Access Compliance Report

Public Rights-of-Way

Intersection ID: 49124	Main Street: CLARKE_CREEK_PY	Cross Street: LEGOLAS_LN	Location: SW
ADA ID: 92765046C45C	Ramp Type: PerpDiag	Initial Pass/Fail: Fail	Overall Compliance: No
		Severity Score: 10

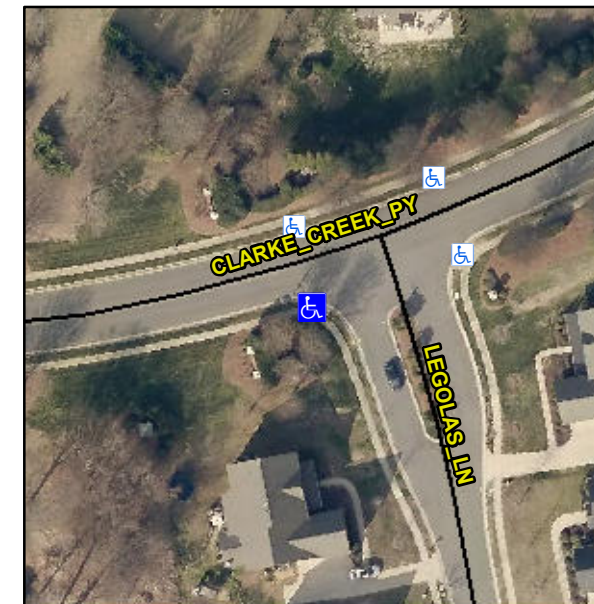
R304.5.1, R304.5.3

Compliance	Description	Data	Compliance	Description	Data
N/A	Ramp Length (in)	44.0	Yes	Ramp Slope (%)	6.2
No	Ramp Width (in)	46.0	No	Ramp XSlope (%)	2.5
N/A	Flare Type LT	N/A	N/A	Flare Type RT	N/A
N/A	Flare Slope LT (%)	N/A	N/A	Flare Slope RT (%)	N/A
N/A	Flare Traversable LT?	N/A	N/A	Flare Traversable RT?	N/A
N/A	Landing Length (in)	N/A	N/A	DWS Provided?	N/A
N/A	Landing Width (in)	N/A	N/A	DWS Contrast?	N/A
N/A	Landing Slope (%)	N/A	N/A	DWS Length (in)	N/A
N/A	Landing X Slope (%)	N/A	N/A	DWS Full Width?	N/A
N/A	Landing Curb? (Y/N)	N/A	N/A	DWS Offset (in)	N/A
N/A	Shared Landing?	N/A			
N/A	Gutter Ponding?	N/A	N/A	Gutter Slope (%)	N/A
N/A	Gutter Lip Ht (in)	N/A	N/A	Gutter X Slope (%)	N/A
N/A	Painted X Walk1?	No	N/A	Painted X Walk2?	No
	X Walk 1 Direction	To E		X Walk 2 Direction	To N
N/A	X Walk 1 Width (in)	N/A	N/A	X Walk 2 Width (in)	N/A
	X Walk 1 Slope (%)	0.3		X Walk 2 Slope (%)	0.5
	X Walk 1 X Slope (%)	2.5		X Walk 2 X Slope (%)	1.1

Remove & Replace Curb Ramp With Two New Directional Ramps or Equivalent.
